Objection submission COM/2019/81 -

Council procedures, SARA re-referral and Public Notification requirements - continued.

Attachment A3 - Plan C1495:00:13B (Showing close-up of Rural 'B' area)

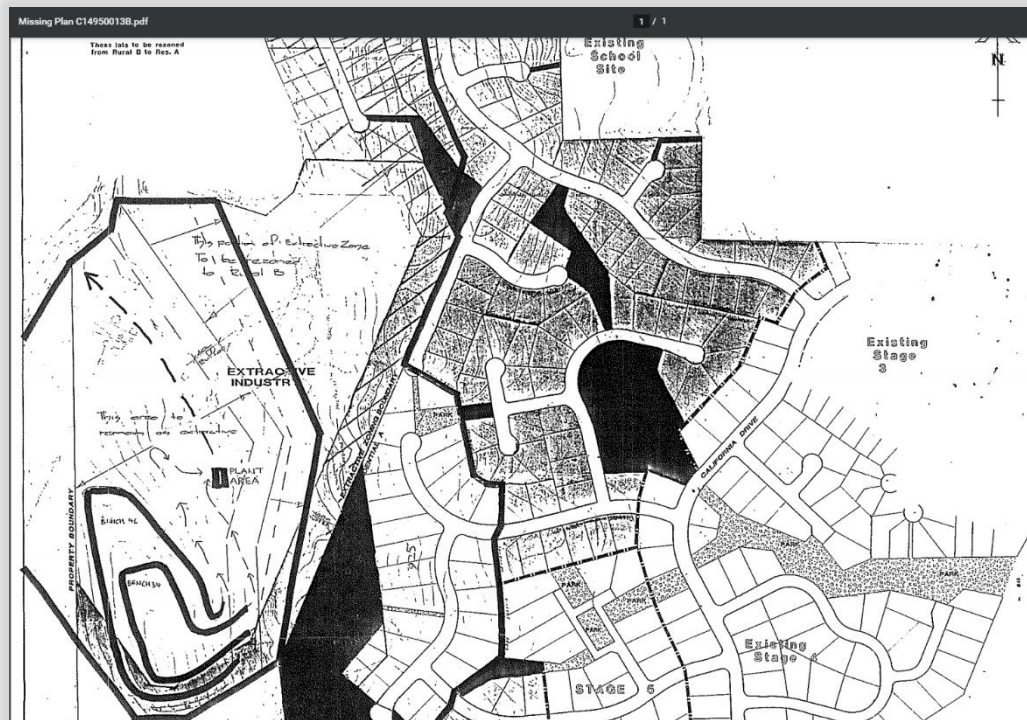
Especially when so much of this highly important, it would seem, was culpably omitted or surreptitiously hidden, for instance omitted plan: 'C1495:00:13B' revealing the true extent of the protected development area, known as Rural 'B' area (reproduced in attachment A2, close up in Attachment A3 and annotated in A4).

Attachment B2 - Plan 362-010 (Third Schedule of Rezoning Agreement) - annotated

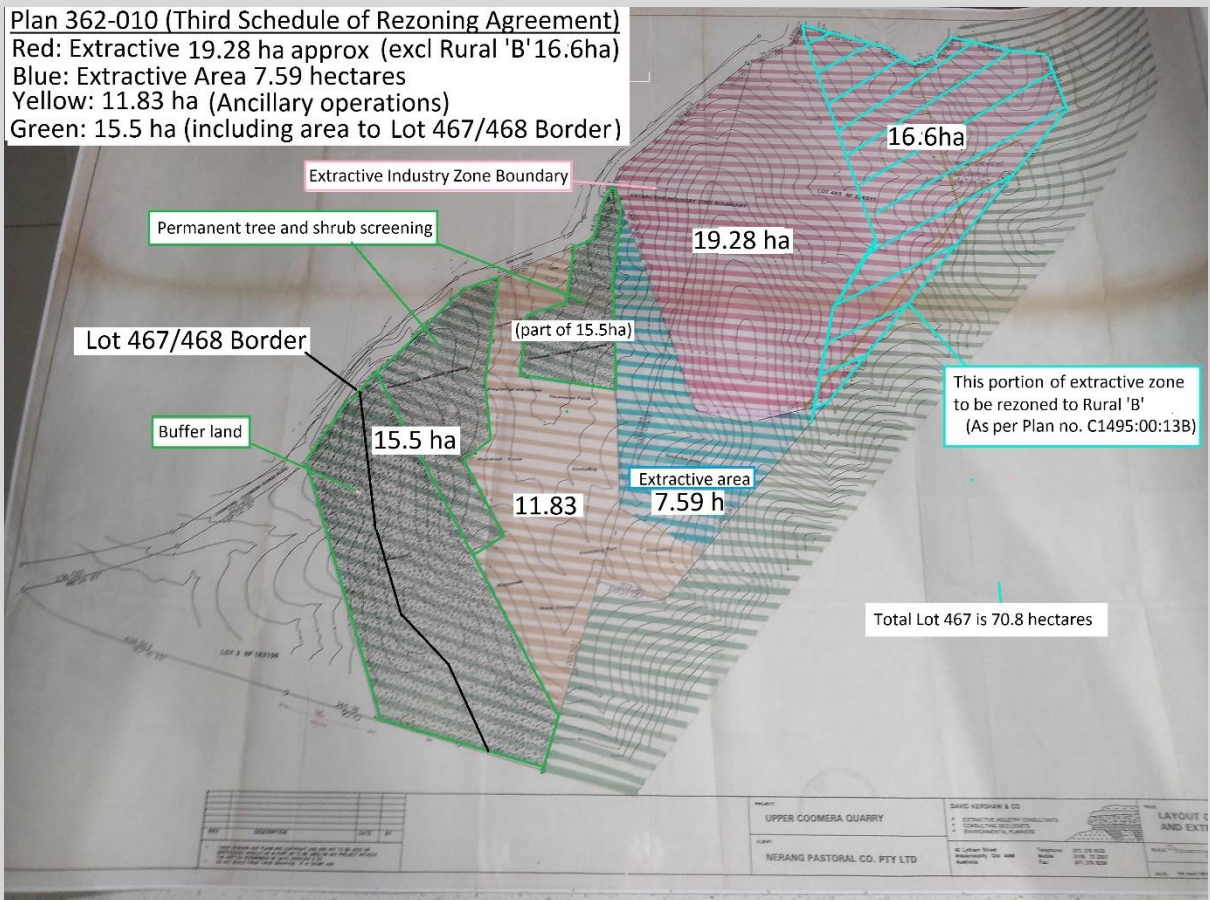
Also, doctored plans such as the 'Third Schedule' of the Rezoning agreement (Attachment B1, annotated in B2) culpably, it would seem, removed and replaced with the relatively innocuous 'Fourth Schedule' (Attachment B3). Thus, it would seem, attempting to suppress information pertaining to the 'Buffer Land' and 'Permanent trees and shrub screening' areas that are part of the current approval (highlighted in attachment B1).

Plan 362-010 (Third Schedule of Rezoning Agreement)  
 Red: Extractive 19.28 ha approx (excl Rural 'B' 16.6ha)  
 Blue: Extractive Area 7.59 hectares  
 Yellow: 11.83 ha (Ancillary operations)  
 Green: 15.5 ha (including area to Lot 467/468 Border)

Note: Extraction prohibited in 2.1 ha of red area (40m buffer required to tamborine -Oxenford Road) and 1 ha extraction prohibited in blue area (40m buffer required from Lot 906).

(Annotated version of attachment C2)

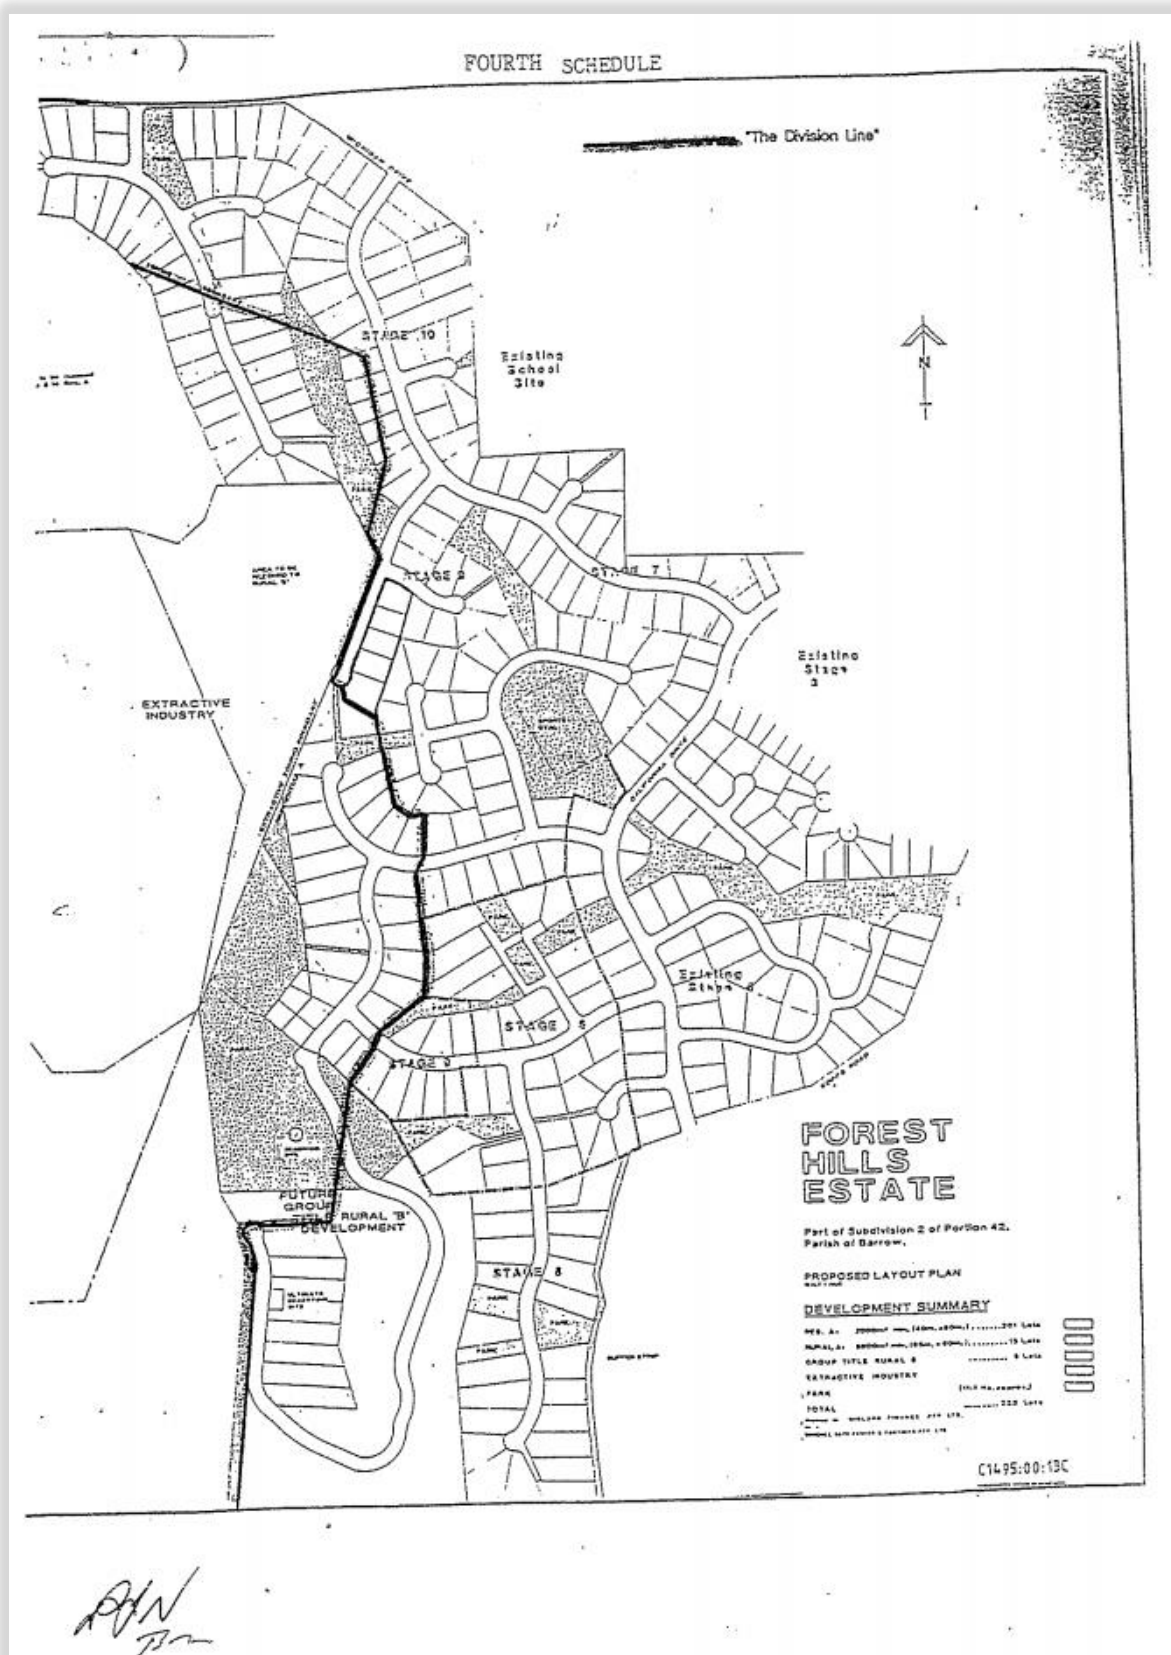
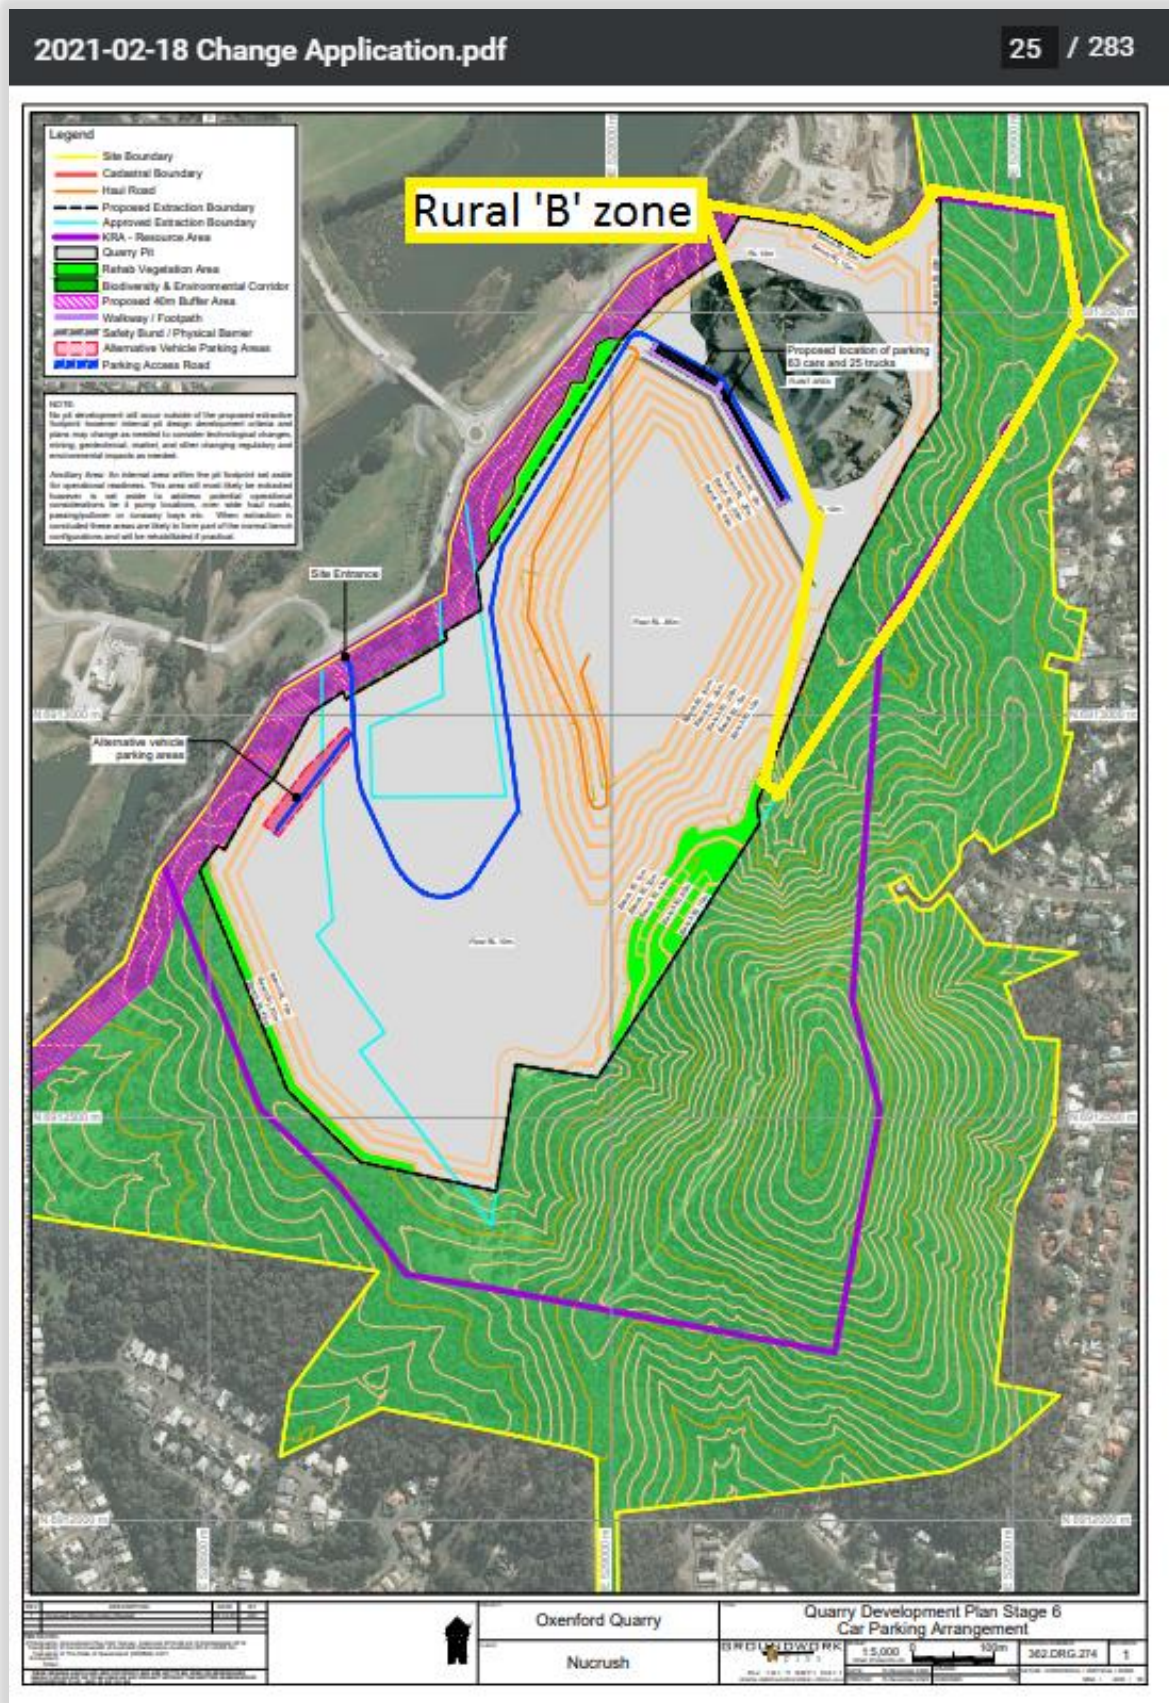
And, what would seem, the highly culpable attempt to deceive Council Planners, SARA and members of the public, by showing the 'Protected development' (Rural 'B') area, which is clearly within the extractive industry zone, Lot 467 (as shown in attachment C1) incorrectly identified as in the completely separate 'Open space' Lot 468 (Attachment C2). For clarification Attachment C3 is an annotated version with the actual position for the Rural 'B' area shown, along with the seemingly highly culpable position in the 'Open space' Lot 468 to the southwest of the extractive industry zone (Lot 467). Also, the 'Buffer land' and 'Permanent Trees and Shrub Screening' areas (15.5 ha) are also highlighted in dark blue. It would seem to me that the 40m buffer land highlighted on the western flank (two small red areas on the western flank in attachment C3) were included as part of the *"Existing Buffer and Rural B Area (30.03 ha)"* to make up the shortfall between the actual Rural 'B' area and the smaller area of Lot 467. This red area is obviously part of the currently *"Approved Disturbance Area"* (as shown in Plan 362-010, attachment B2), however, it would seem to have been surreptitiously re-labelled in Attachment C2/C3 to make up the shortfall between the Rural 'B' area (16.6ha) and Lot 468 (13.23ha).

Attachment C3 also clearly shows how members of the public were, it would seem, misled at the time of original public notification into believing 7.36 ha within the prohibited development area (Rural 'B') was approved extractive footprint that was being magnanimously released for the benefit of local residents and the local environment in the area as it is labelled as: *"Previously approved Area, however, proposed to be left undisturbed (7.36ha)"* (Attachment C3). However, this is clearly part of the protected development area, as highlighted in the omitted Plan: 'C1495:00:13B' (reproduced in attachment A2, A3 and A4). In fact, local residents in this area (notably Emerson Way), where I believe canvassed prior to public notification, on behalf of the applicant, and were warned that objecting to the proposed development application would mean they extractive footprint could be virtually up to their backyard instead of 150 metres or so from their properties (as opposed to the 400 metres current approval would actually allow but not divulged by the canvassers). Clearly it would seem, local

Attachment C3 also highlights how the development application includes the prohibited development area (Rural 'B') as part of its: *"Approved Disturbance Area (56.02 ha)"*. This area is definitely not part of the *"Approved Disturbance Area"* as clearly stated in the 1992 Rezoning Agreement and as shown in 'C1495:00:13B' (reproduced in attachment A2, A3 and A4). Also, this claimed *"Approved Disturbance Area (56.02 ha)"* includes 15.5 ha of *'Buffer Land'* and *'Permanent Trees and shrub screening'* as shown in Plan 362-010 (reproduced in attachment B2). It would seem, the *"Approved Disturbances Area"* is not 56.02 ha, as claimed, but is less than half of this at approximately 23.77 ha (as shown in attachment B2). Again, I believe, seriously and culpably misleading Council Planners, the SARA referral agency and members of the public as to the scale of the proposed development application and the current approval.

Total extractive footprint is 23.77 ha  $(19.28 - 2.1) + (7.59 - 1)$  NOT the claimed 56.02 ha

Attachment C4 - Open Space Lot 468 in relation to the Extractive Industry Zone (and KRA)

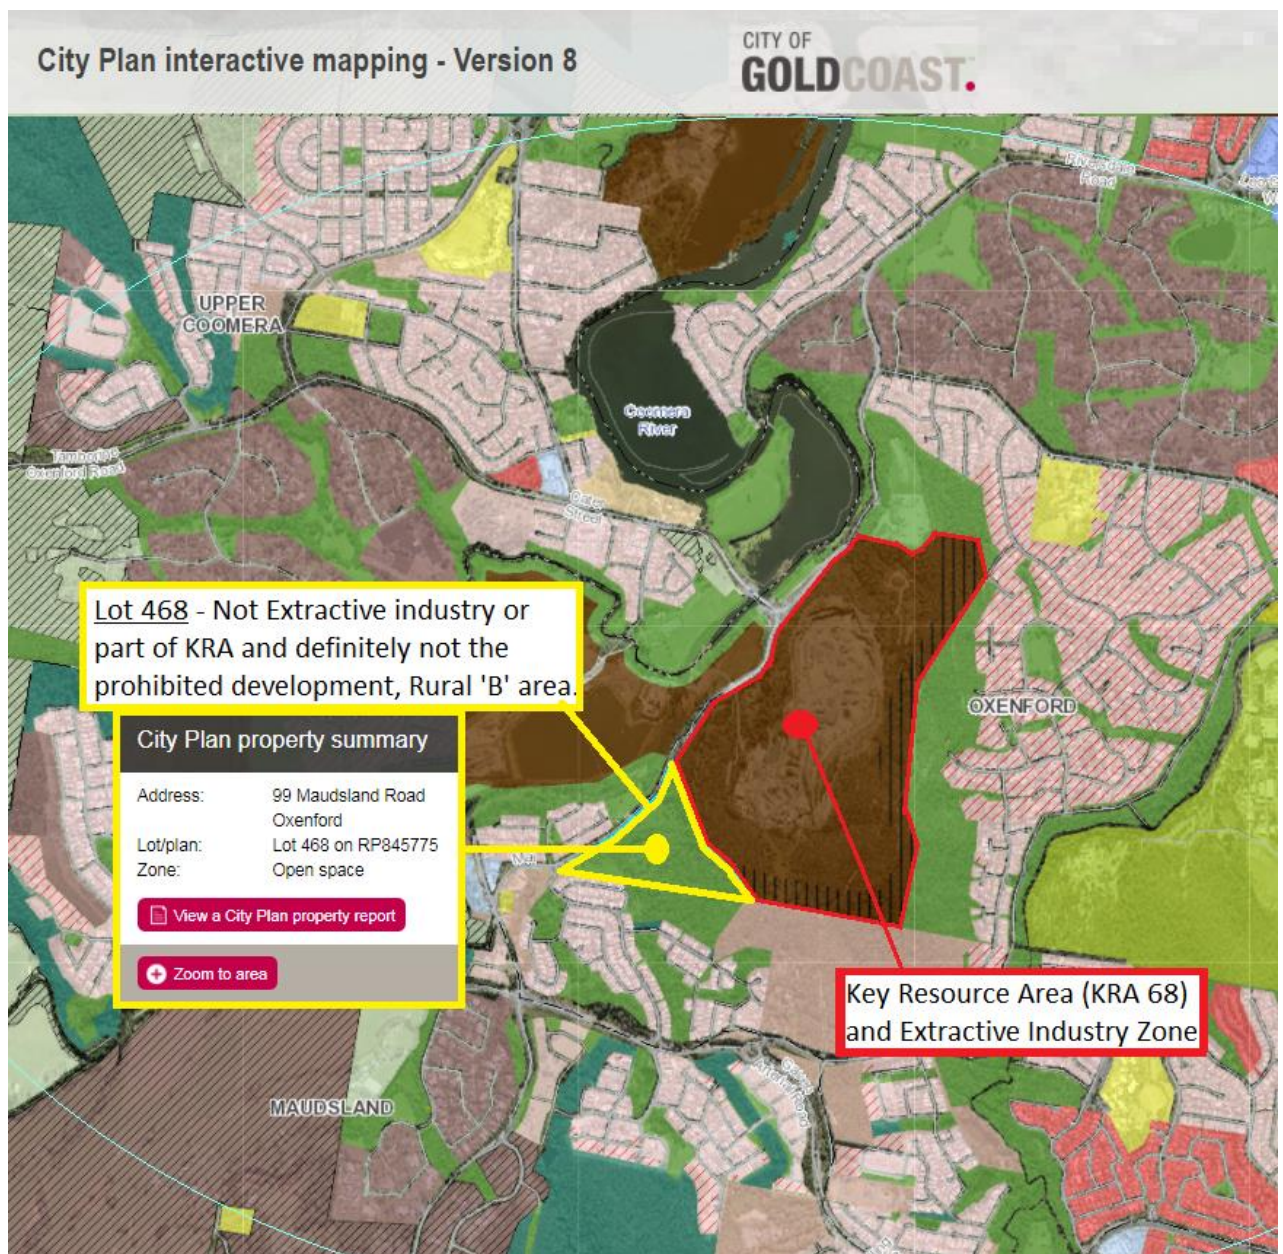
Note, for clarification Lot 467 (the extractive zone and KRA) and the open space Lot 468 are identified in the City Interactive Map in attachment C4).
